Response to Submissions Reports

MP10_0204 MOD 6

Property:
Catherine Hill Bay

Applicant:
Coastal Hamlets Pty Limited

Figure 1: Indicative Stage 7 Stormwater Layout

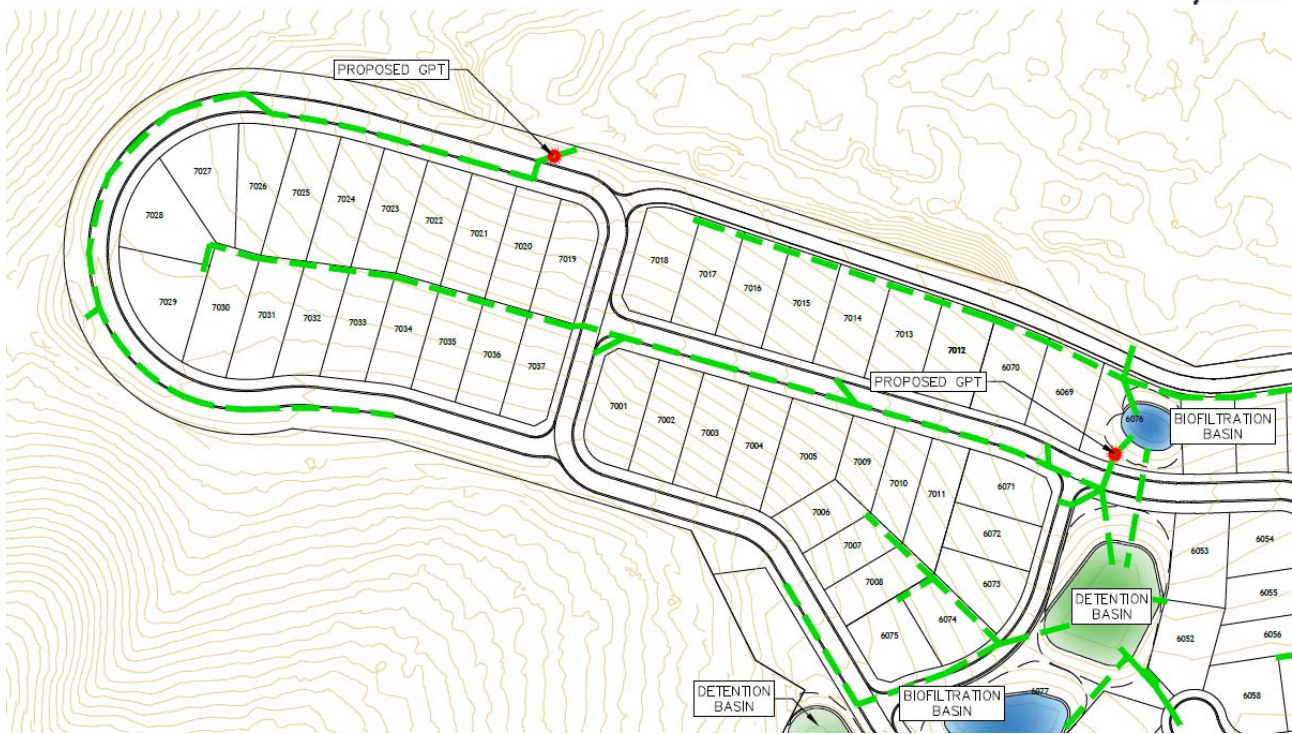
1. All retaining walls required within the subdivision should be made from decorative masonry and should be located outside of the public road reserve;
2. There does not appear to be any provision for the treatment of stormwater in Stage 7. Council's normal requirements are that stormwater detention and stormwater quality controls are provided for stormwater prior to the stormwater being discharged offsite.
3. The stormwater from Stage 7 is proposed to be discharged directly to the adjoining National Park without stormwater treatment (as identified in point 2 above) and without the provision of easements on the National Park lands.

2. The majority of the stormwater generated from Stage 7 subdivision is directed to the east through Stage 6. The stormwater is then treated via the stormwater quality controls within Stage 6, being a combination of gross pollutant traps (GPT) and biofiltration basins. The remaining area of Stage 7 that cannot be discharged through Stage 6 due to site topography is combined with uphill runoff from National Park lands and treated via a GPT, refer to Figure 1.

Stormwater detention controls are located within the Stage 6 site area. A portion of the Stage 7 subdivision is directed into the detention basins within Stage 6. The remaining area of Stage 7 cannot discharge to the detention basins due to site topography. For this reason, the detention basins are sized to over detain flows, to ensure flows downstream of the site are maintained at pre-developed levels.

Plan of: STAGE 7
COMPARISON OF APPROVED AND PROPOSED LOT LAYOUT

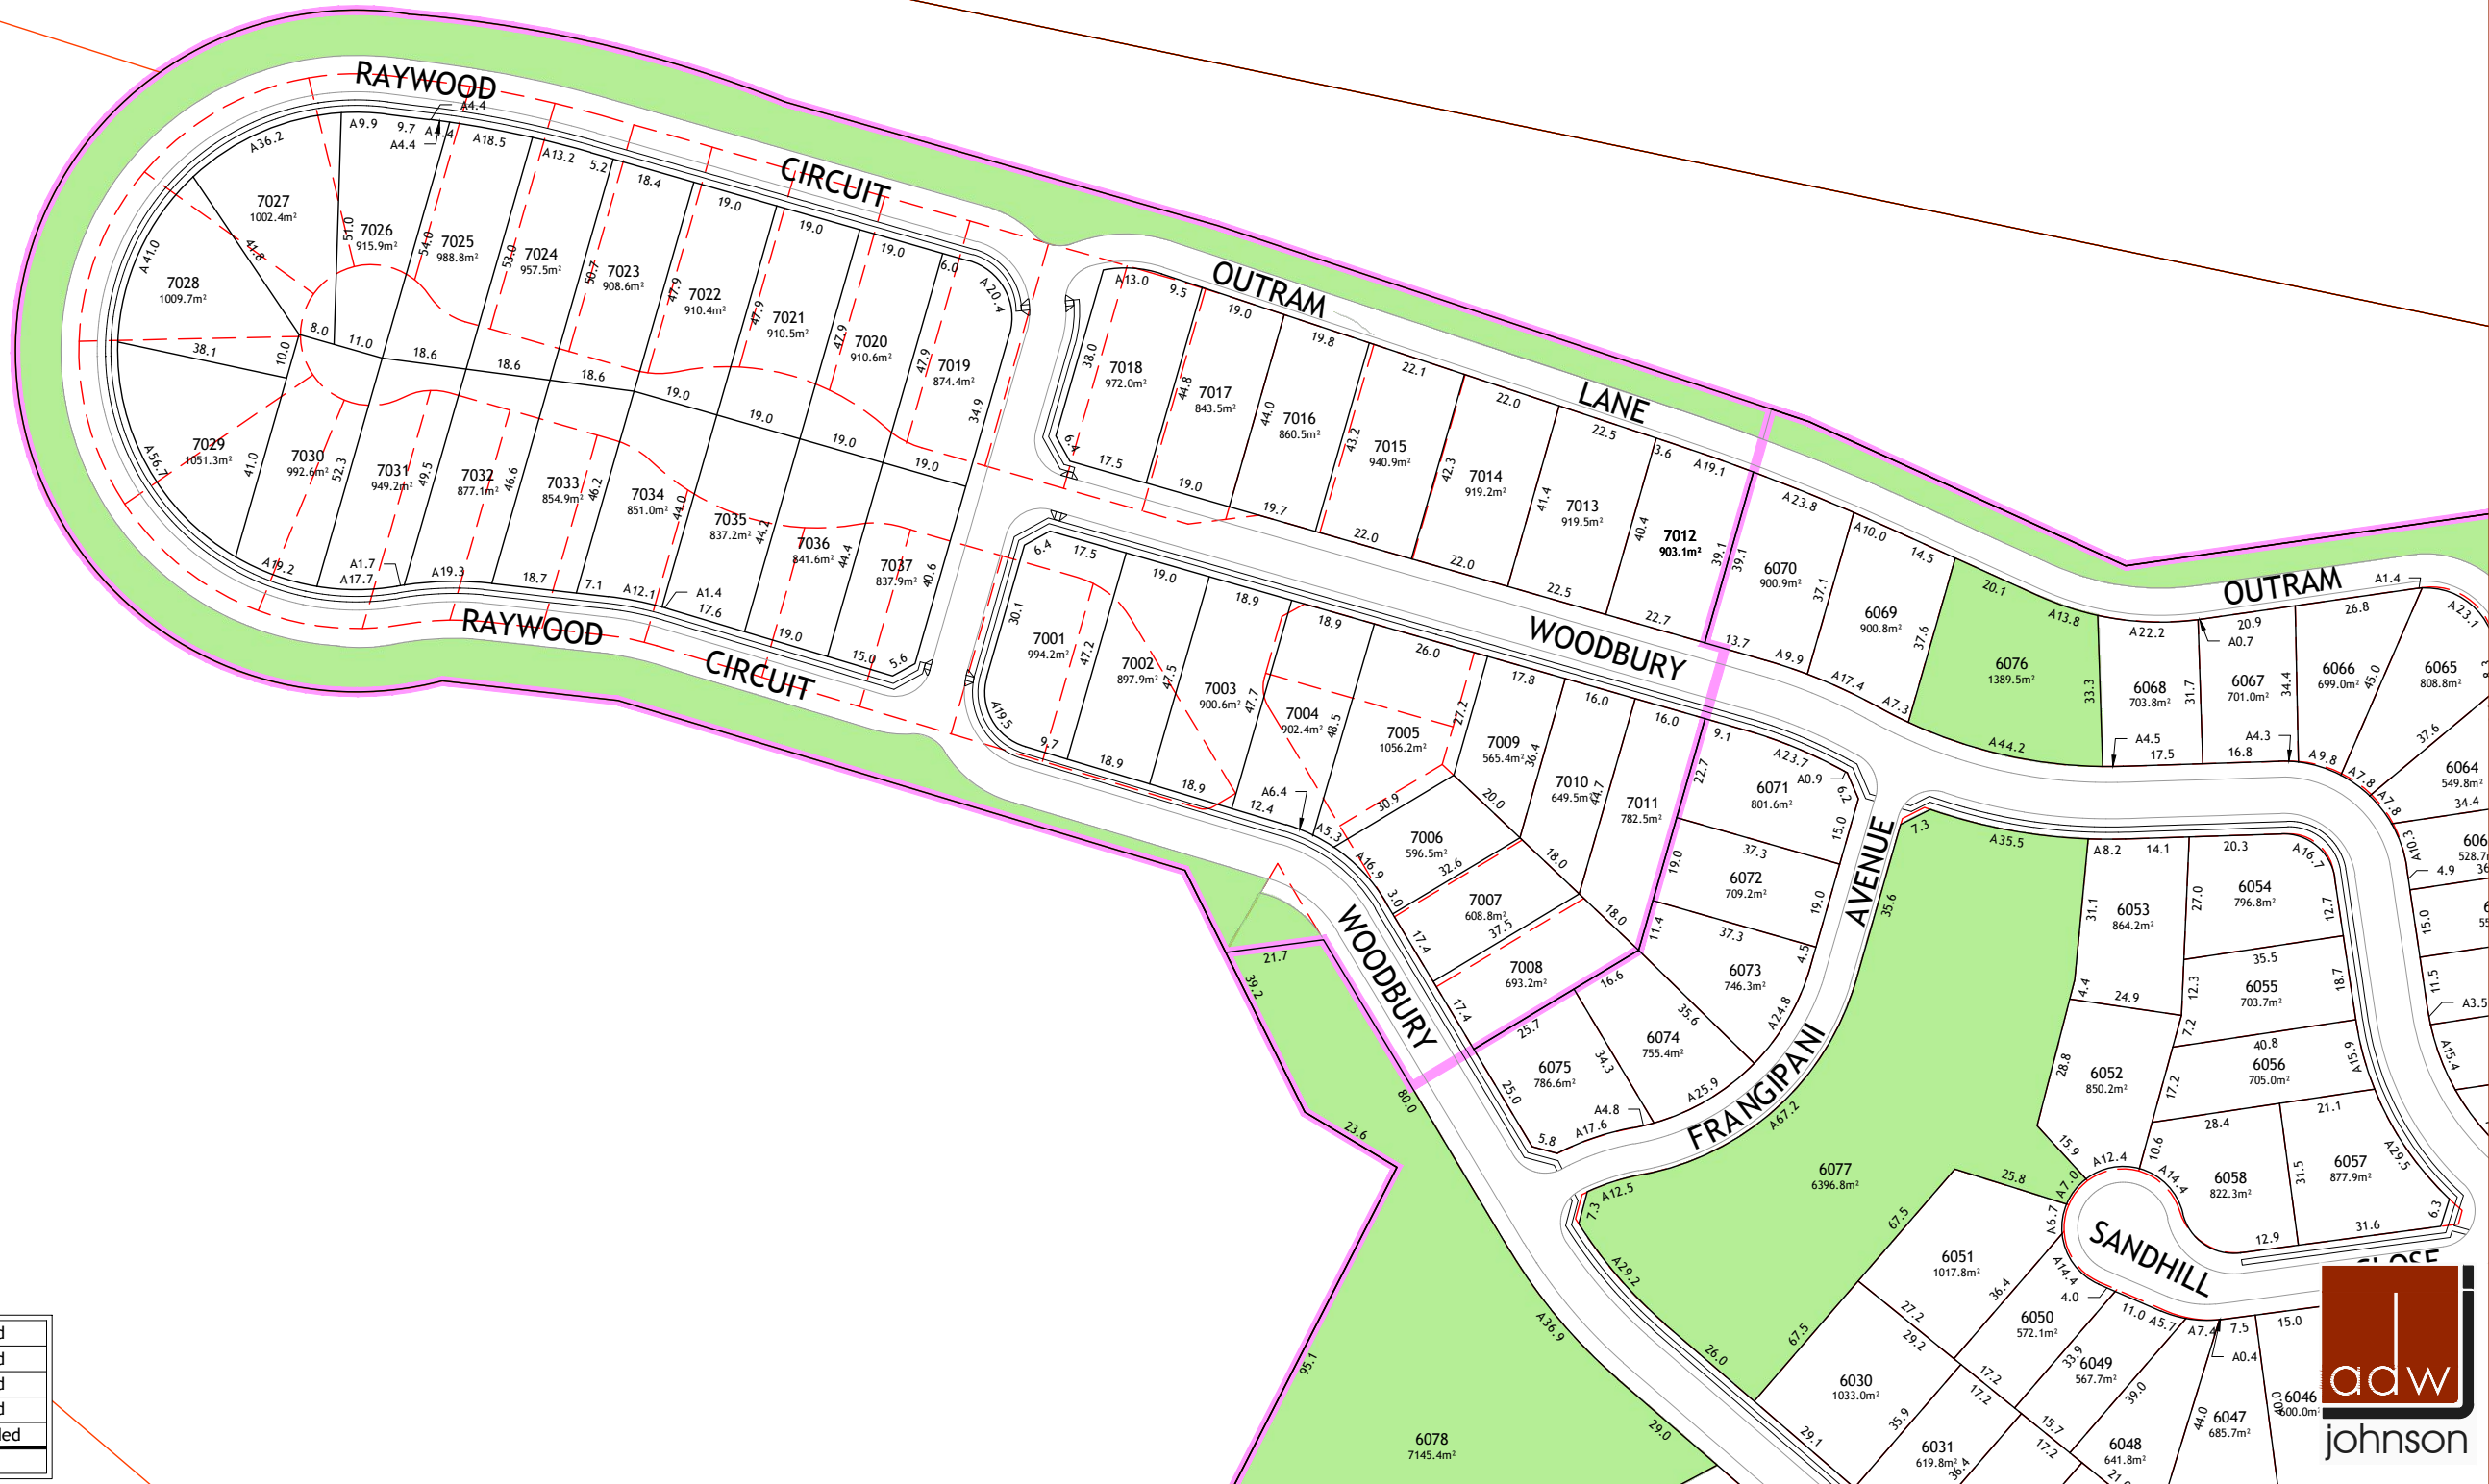
EXTERNAL ROAD SHORTENED AND LOTS RECONFIGURED WITHIN STAGE 7. (SAME LOT COUNT)
